APPLICANT: Feeding God's Children Ministry	PETITION NO:	Z-40
(404) 358-0443	HEARING DATE (PC):	06-03-14
REPRESENTATIVE: Sheila D. Bynum	HEARING DATE (BOC): _	06-17-14
(404) 358-0443	PRESENT ZONING:	RA-5
TITLEHOLDER: Sheila Bynum		
	PROPOSED ZONING:	R-30
PROPERTY LOCATION: East side of Sandtown Road, south of		
Windy Hill Road.	PROPOSED USE:	Church
ACCESS TO PROPERTY: Sandtown Road	SIZE OF TRACT:	2.11 acres
	DISTRICT:	17
PHYSICAL CHARACTERISTICS TO SITE: Undeveloped, wooded	LAND LOT(S):	202
	PARCEL(S):	65
	TAXES: PAID X DU	JE
CONTIGUOUS ZONING/DEVELOPMENT	COMMISSION DISTRICT	:_4

The applicant is requesting a rezoning of the property from the existing RA-5 single-family attached/detached residential district to the R-30 single-family residential district in order to construct and operate a church upon the site. The change in zoning is necessary as the current RA-5 district was approved under case Z-65 of 2005 that stipulated a five (5) lot subdivision subject to several conditions having a density of 2.37 units per acre. The proposed church will utilize a proposed 50 ft by 100 ft prefabricated steel building with anticipation of a "future" 50 ft by 100 ft prefabricated steel buildin

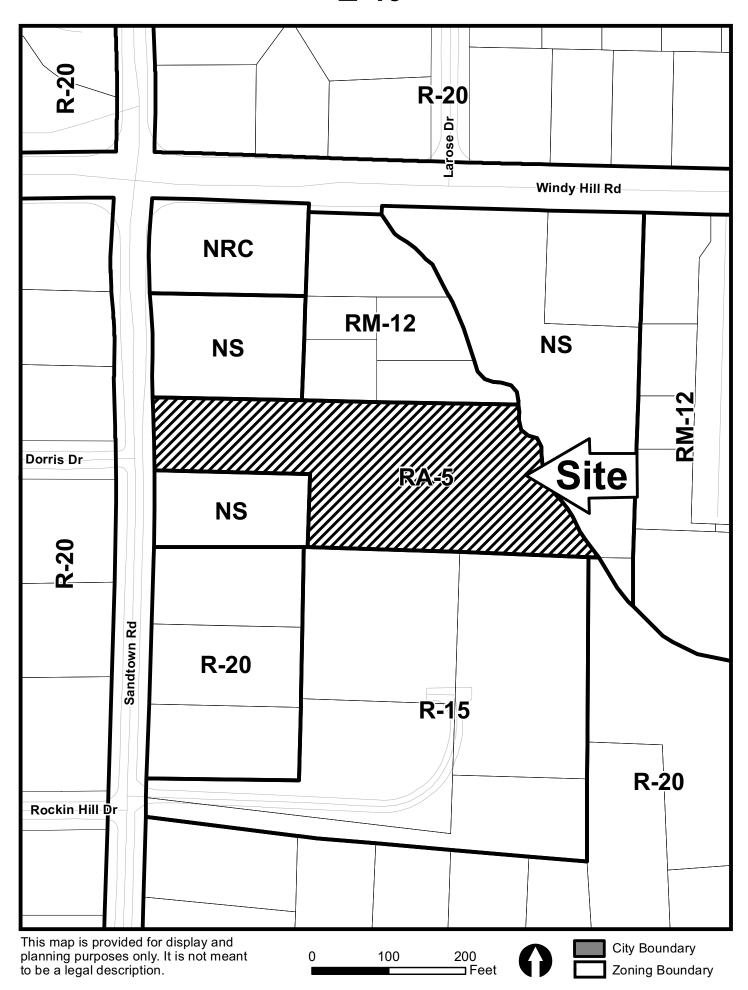
The applicant will need a simultaneous variance to waive the required five (5) acres for a church in residential zoning to 2.07 acres as well as the required 50 foot setback as the site plan indicates the church being 20 feet from the western property line and 42 feet from the southern property line. Also, the Code requires that churches be located where primary access is provided from an arterial or major collector roadway and Sandtown Road is only categorized as a minor collector.

1. Contrary to the delineation on the site plan, this site is heavily encumbered by floodplain. Approximately 50% of the site, which is roughly the rear 230 feet of the parcel, is within the 100-year floodplain. This includes part of the main building, the future expansion and the proposed detention pond. All of these will need to be relocated outside the floodplain limits. While it appears possible to relocate at least one building and the detention pond outside the floodplain, most if not all of the parking will need to be located within the floodplain. In any case, a major site plan revision will be required.
